- Variation of Condition to Proposed Extension.
1. Omit one roof window.
 2. Floor level to be as existing.
 3. Omit window & door arrangement
Add sliding doors & glazed screens.
 4. Gable: Omit glazed gable spandrel panel.
Add: Stone facing & boarded gable panel.

Proposed:
Alterations & EXTENSIONS
at
CHAPEL GARTH
EGTON BRIDGE
WHITBY

Drawing:
PROPOSED
ELEVATIONS II

Drawing No. 316/07 A
Date: JUNE 2021
Scale: 1/100

NORTH WEST ELEVATION

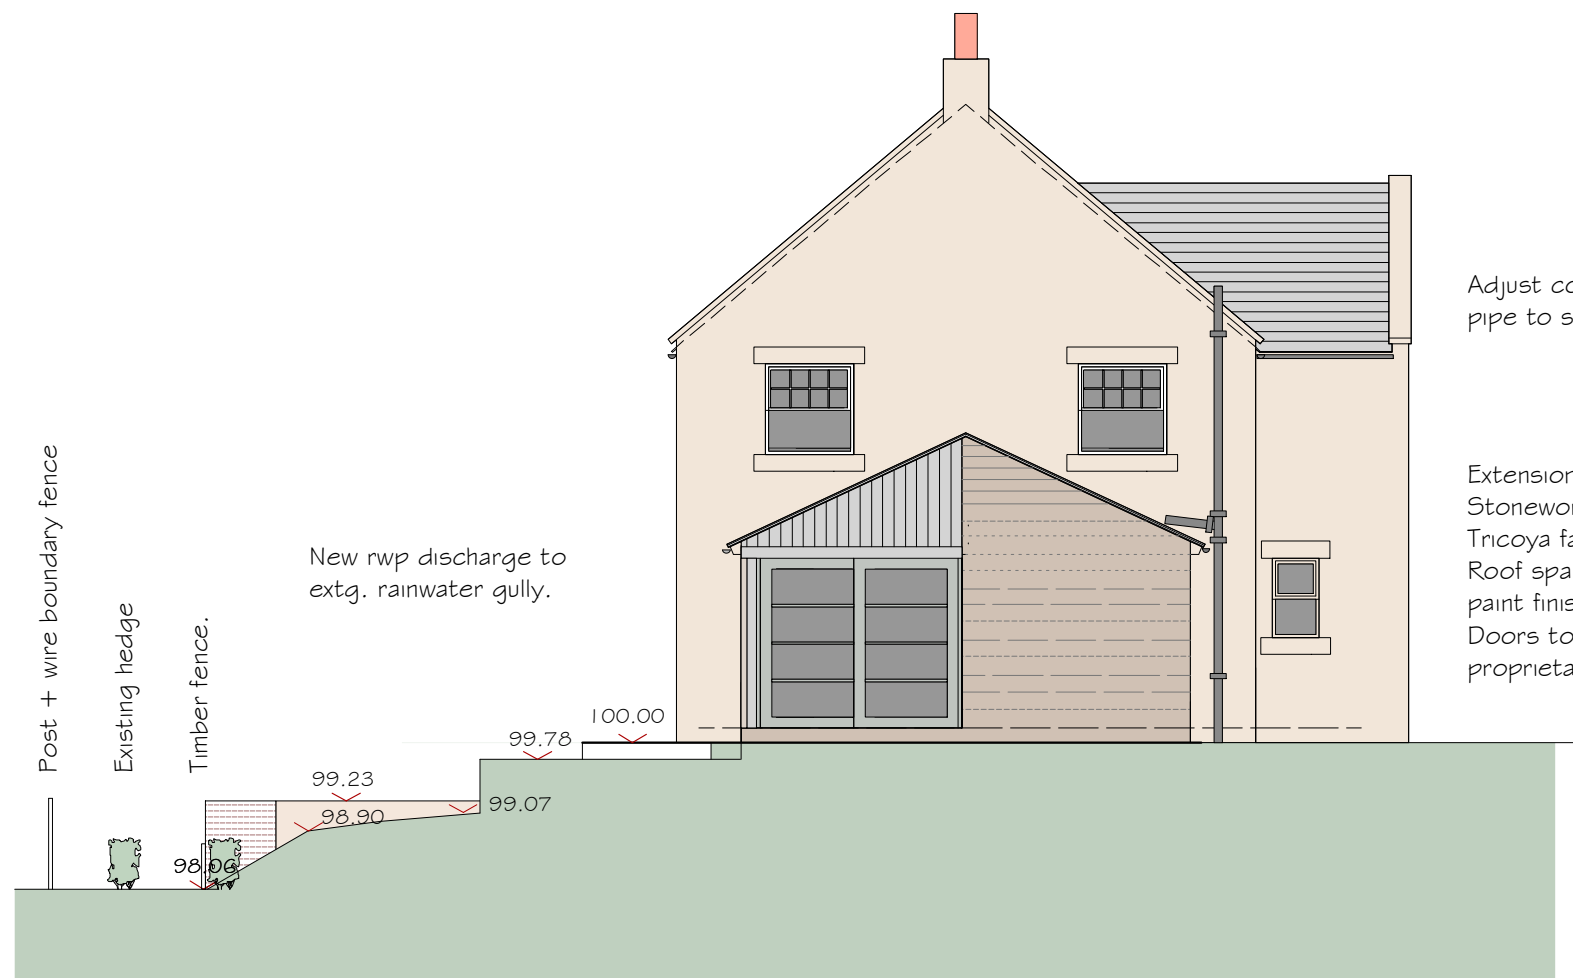
revision A. 9.9.21
Boarding to be vertical.

Adjust configuration of soil & vent pipe to suit new extension roof.
